Planning & Listed Building Conditions Discharge

0706 \_7.04\_120626

Drawings submitted in response to the following conditions:

# LIGHTHOUSE BLOCK KINGS CROSS

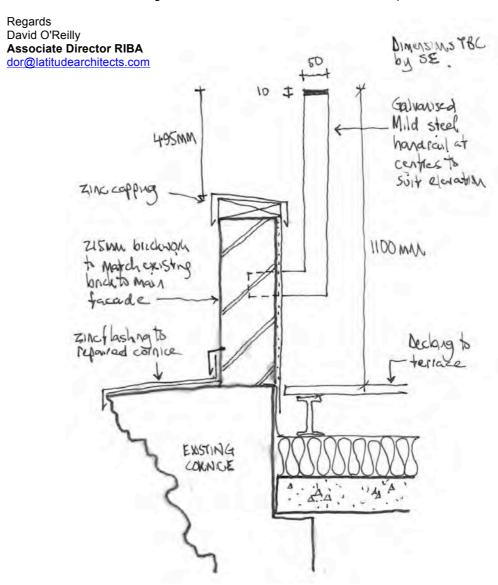
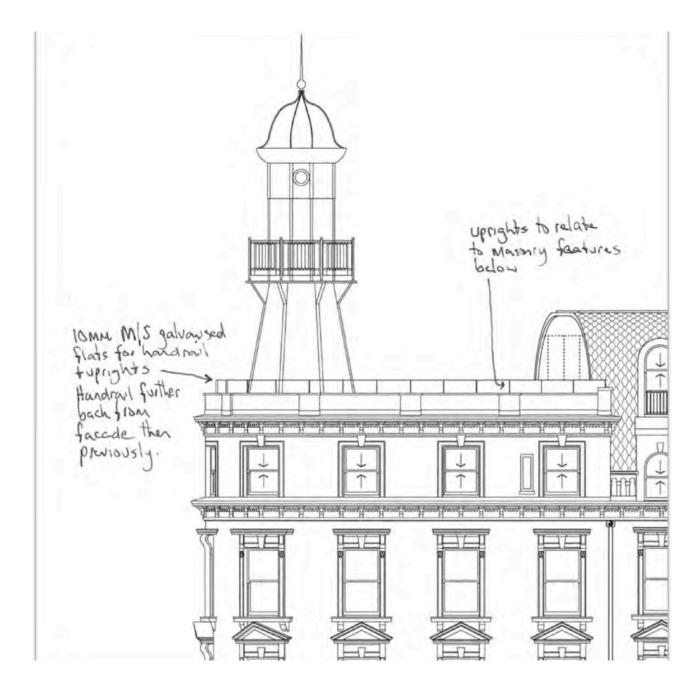
I can confirm that the glazed balustrade to the 297-380 would be seen in long and short views and is considered harm the character and appearance of the listed section of the block.

- Reduce the size of the terrace and set back the balustrade to the inner side of the lighthouse structure this would prevent people walking around the structure but would prevent the balustrade from being seen or,
- Redesign the balustrade to be more sympathetic with the age and style. This could beachieved by installed metal balustrade or wire handrail

The revised drawings (which we are issuing to you as draft for discussion), shows the glass balustrade replaced with a galvanised mild steel handrail and uprights (approx.. 10mm wide by 50mm deep) in line and centred with the piers below. We are proposing to replace the brick at this level for a few reasons. It is a poor quality brick in relation to the rest of the façade below and it is in poor condition with some serious cracking throughout. It is also only 100mm thick and we believe 215mm thick brick would be more secure for the future of the building. We would replace it with a Gault brick to match the existing. Due to the increased thickness of the wall and the detail of the handrail connection with the wall, it will naturally be set back further from the façade than previously shown. Hopefully this responds to both of your suggestions below.

Thanks for the email. I am happy to accept the balustrade detail (for the whole of the terrace) as shown. Please amend drawings accordingly.

I am unsure of finish but would recommend the balustrade by powder coated black rather than metallic

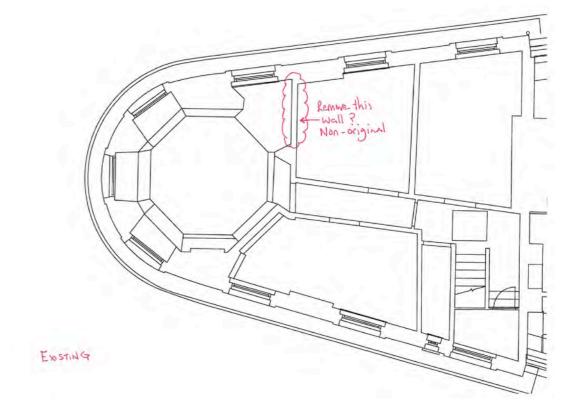
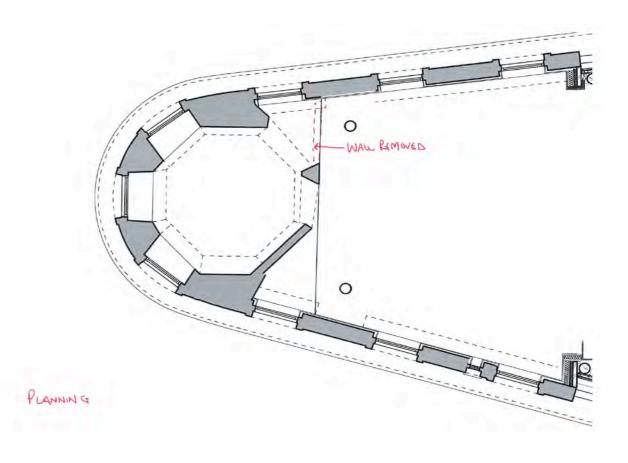
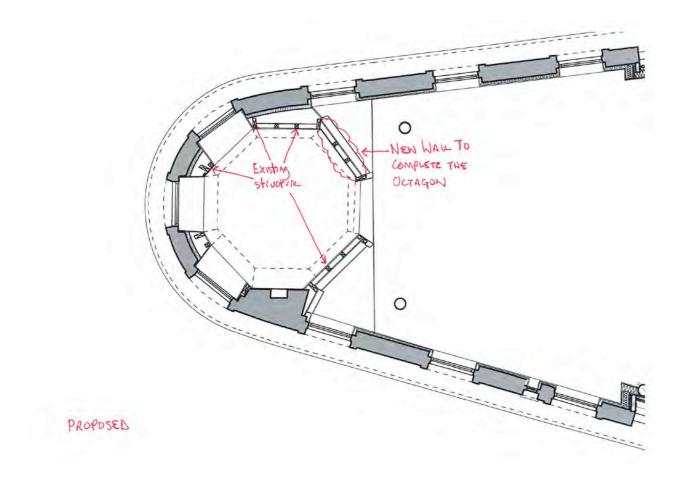
Having done further reviews of the 3rd floor room directly under the Lighthouse with the structural engineers, we believe the wall that runs north-south (and as a result doesn't complete the octagon) is not original.

The structural engineers believe the wall that would have completed the octagon was previously removed and to allow this to happen the north-south wall was erected to help with the bracing of the Lighthouse structure above.

To remove the north-south wall (which we have planning approval for) we would need to reinstate the original 135 degree angle wall. This is shown on the attached part plans. We as a design team think this is a positive move and hope you also agree with this.

Thanks for the email. All very clear. I agree with your decision and would be happy to accept the proposed revision.

PR/CT05: Scrubbing brickwork following application Of Neolith 625 to heavily stained area around blocked downpipe.

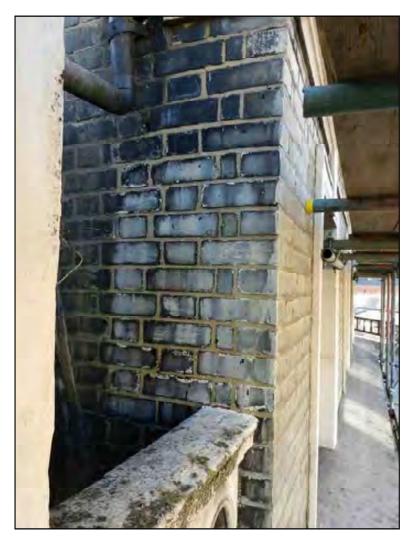
**PR/CT06:** Post clean, surface soiling improved but hardened deposits remain. Further cleaning required to improve finish.

# THE LIGHTHOUSE BLOCK KINGS CROSS FACADE CONDITION SURVEY NORTH ELEVATION

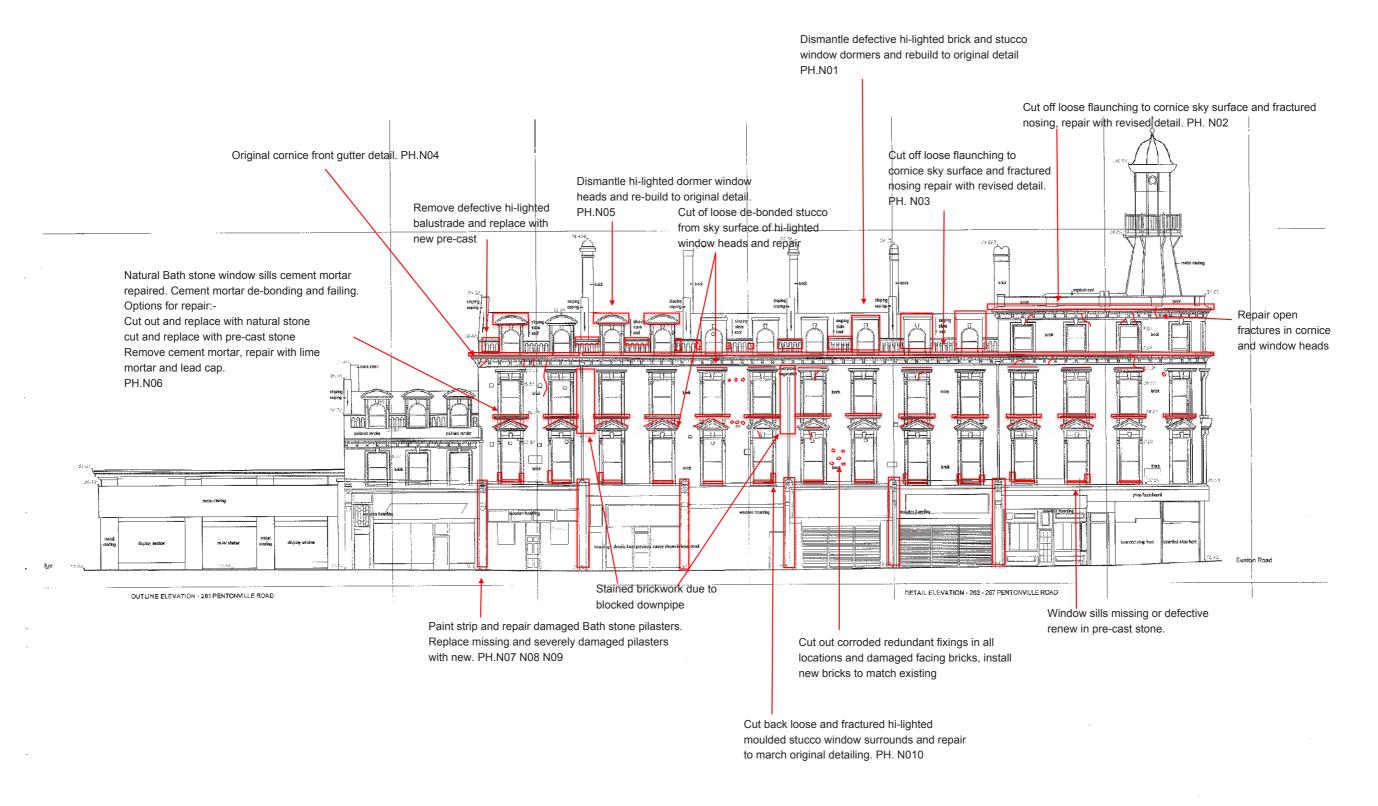
The hard dense cement screed used to re-fluanch the cornices has de-bonded from the original substrate and needs to be removed and replaced with an improved detail to ensure that rainwater runs off and away from the building facades. The condition of the substrate exposed during the investigation trials was found to be in a poor condition which if found to be typical will require extensive re-building of the cornice upper moulded section.

The introduction of a lead or zinc capping and flashing may be considered if practical which would help provide protection to the repaired cornice and a drip detail to aid the water dispersion.

# THE LIGHTHOUSE BLOCK KINGS CROSS FACADE CONDITION SURVEY EAST WEST ELEVATION

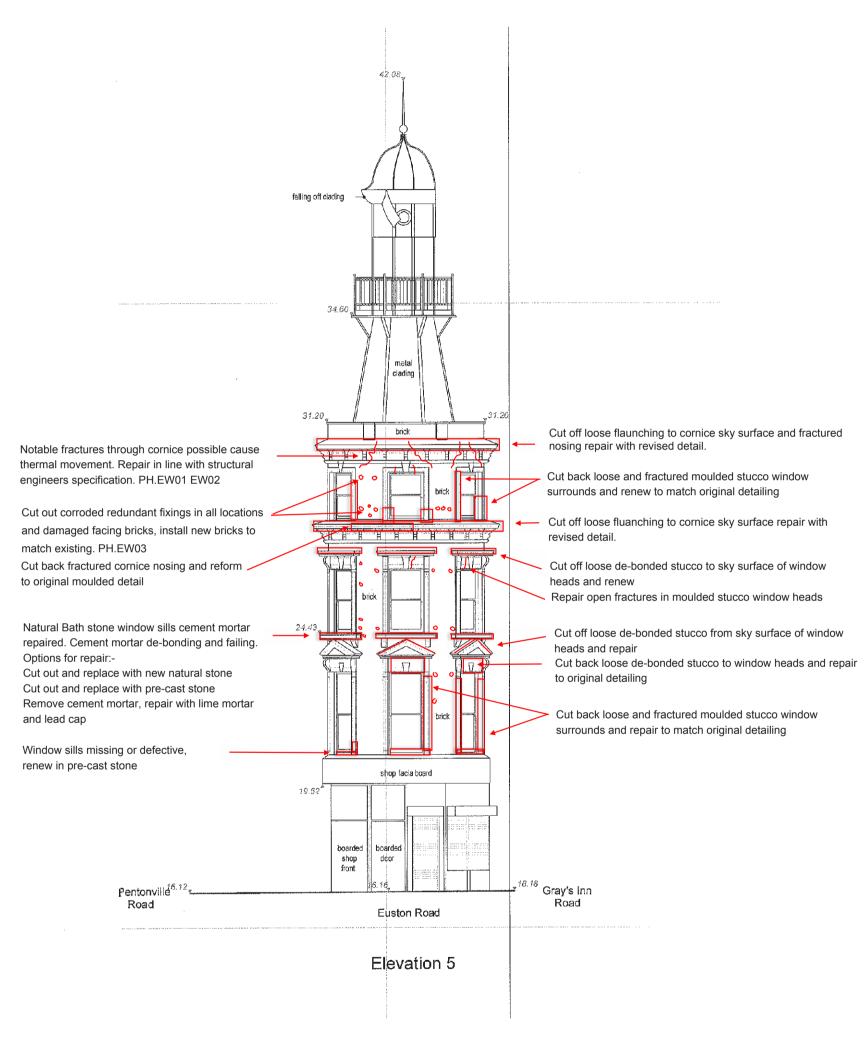
**PH. EW01 EW02.** Significant fractures through upper cornice and parapet wall possibly due to thermal movement. Replace and repair sky surface and nosing as previous. Introduce control measures as necessary in accordance with structural engineers specification to prevent further possible movement.
